CONSTRUCTION SUMMARY

Mountainview Heights (G) - Russell Gardens Building Ltd.

LOT / PHASE 111 / 2	REG. PLAN # 62M-1238	HOUSE TYPE Rosewood 1 Elev 3		
------------------------	-------------------------	---------------------------------	--	--

ROSEWOOD 1
2,655 sq.ft. includes 12 sq.ft. of open area

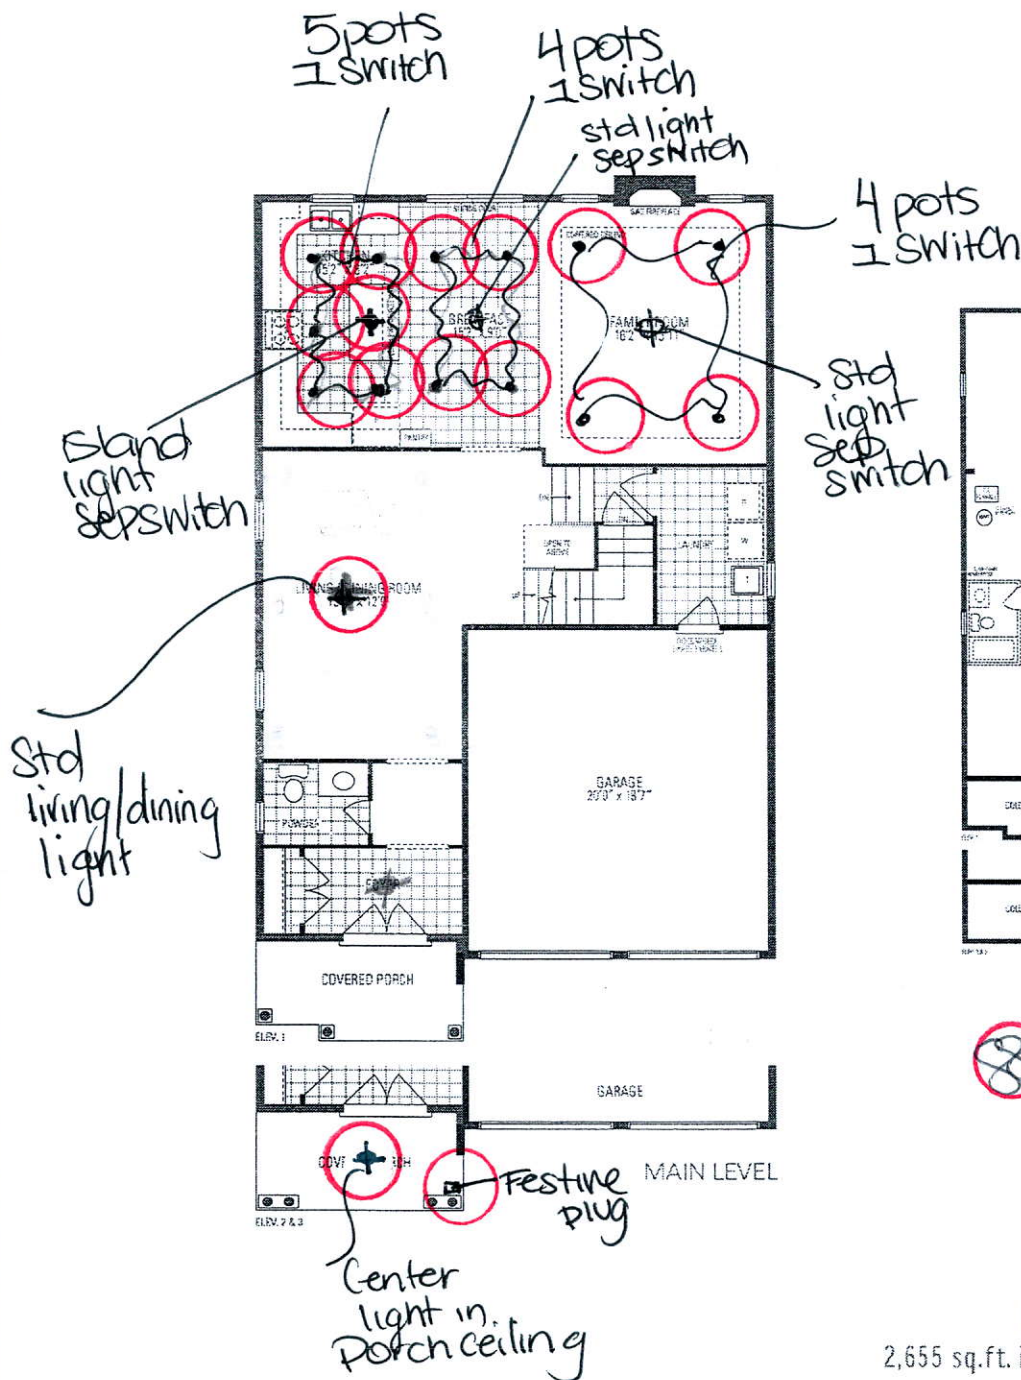
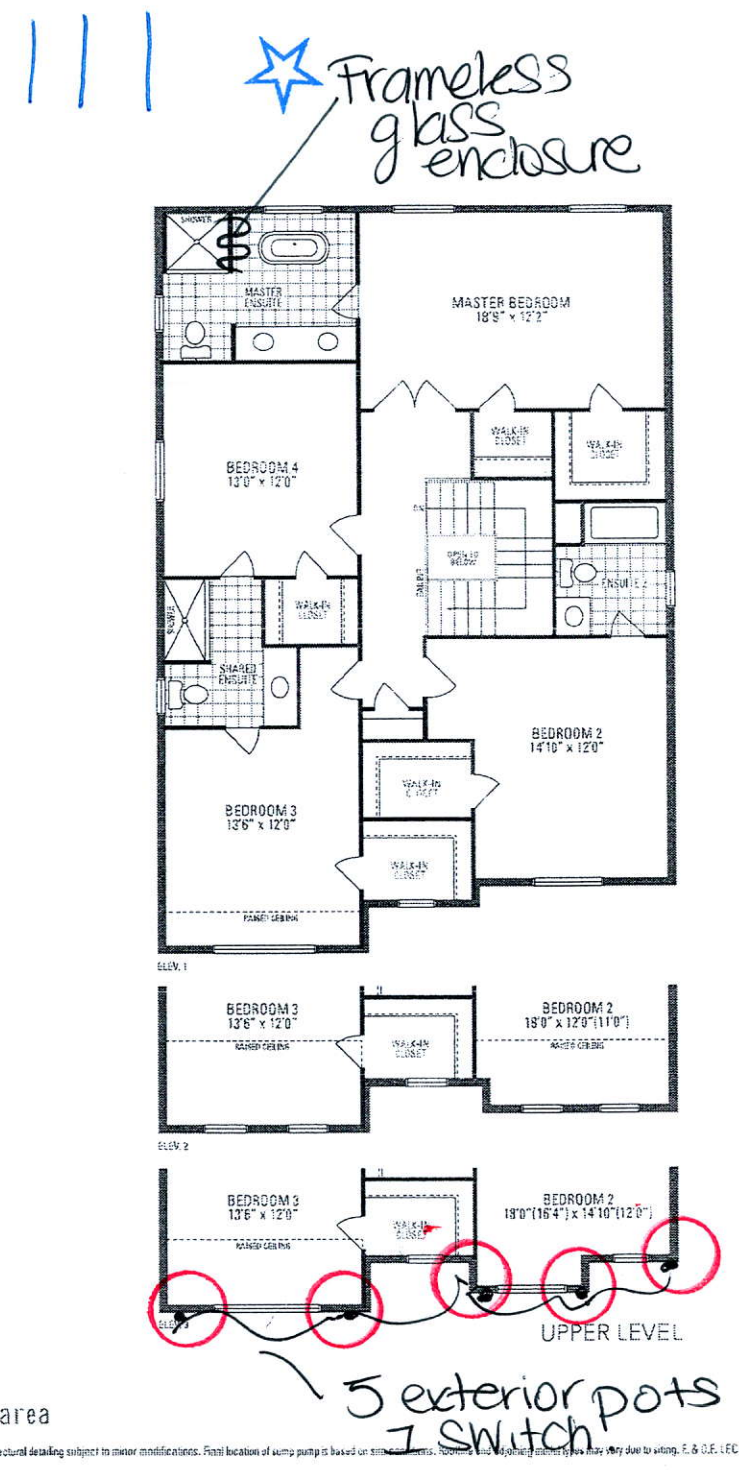
1 - PLUG - ELECTRICAL PLUG WITH GFI AND SWITCH - FOR FESTIVE LIGHTING 05Jun18 Note:	
13 - POT LIGHT - LED - FIRST FLOOR INSTALLATION 05Jun18 Note:	
1 - STANDARD DINING ROOM LIGHT TO BE CENTERED BETWEEN LIVING AND DINING ROOM 05Jun18 Note:	
1 - RELOCATE STANDARD PORCH LIGHT TO BE CENTERED IN PORCH CEILING 05Jun18 Note:	
5 - POT LIGHT - EXTERIOR - SOFFIT MOUNT - REGULAR VOLTAGE 05Jun18 Note:	
1 - RELOCATE STANDARD KITCHEN LIGHT TO BE CENTERED OVER ISLAND 05Jun18 Note:	
1 - 200 AMP ELECTRICAL SERVICE 05Jun18 Note:
